Access Compliance Report Public Rights-of-Way (Curb Ramps)

Intersection ID: 45699 Main Street: E_ARROWOOD_RD Cross Street: KINGS_CREEK_DR Location: SW

ADA ID: 7D6BF02ADCBA Ramp Type: PerpDiag Initial Pass/Fail: Fail Overall Compliance: No Severity Score: 25

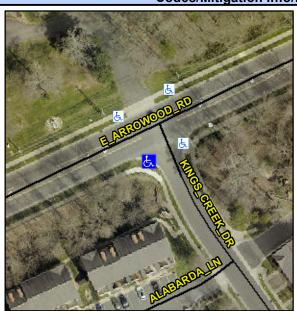
Not Found, R304.5.3

Field Measure	ements/C	ompo	nent Compliance	
Comp	Compliance Description		Comp	liance Description	Data
N/A	Ramp Length (in)	96.0	Yes	Ramp Slope (%)	7.4
Yes	Ramp Width (in)	57.0	No	Ramp XSlope (%)	10.5
N/A	Flare Type LT	N/A	N/A	Flare Type RT	N/A
N/A	Flare Slope LT (%)	N/A	N/A	Flare Slope RT (%)	N/A
N/A	Flare Traversable LT?	N/A	N/A	Flare Traversable RT?	N/A
N/A	Landing Length (in)	N/A	N/A	DWS Provided?	N/A
N/A	Landing Width (in)	N/A	N/A	DWS Contrast?	N/A
N/A	Landing Slope (%)	N/A	N/A	DWS Length (in)	N/A
N/A	Landing X Slope (%)	N/A	N/A	DWS Full Width?	N/A
N/A	Landing Curb? (Y/N)	N/A	N/A	DWS Offset (in)	N/A
N/A	Shared Landing?	N/A			
N/A	Gutter Ponding?	N/A	N/A	Gutter Slope (%)	N/A
N/A	Gutter Lip Ht (in)	N/A	N/A	Gutter X Slope (%)	N/A
N/A	Painted X Walk1?	No	N/A	Painted X Walk2?	No
	X Walk 1 Direction	To NE		X Walk 2 Direction	To N
N/A	X Walk 1 Width (in)	N/A	N/A	X Walk 2 Width (in)	N/A
	X Walk 1 Slope (%)	5.4		X Walk 2 Slope (%)	9.2

X Walk 1 X Slope (%)	8.7		X Walk 2 X Slope (%)	6.1
N/A	Ramp inside XWalk1?	N/A	N/A	Ramp inside XWalk2?	N/A
	Road Slope (%)	12.0	N/A	Clear Space?	N/A
	Road X Slope (%)	1.1	N/A	Clear Space to XWalk (in)	N/A
N/A	Any Obstructions?	N/A	N/A	Storm Grate/Utility Hazard?	N/A
	Obstruction Type		l	Storm Grate/Utility Type	
		N/A			N/A
			Yes	Surface Condition? (G/P)	Good

Remove & Replace Curb Ramp With
Two New Directional Ramps or
Equivalent.
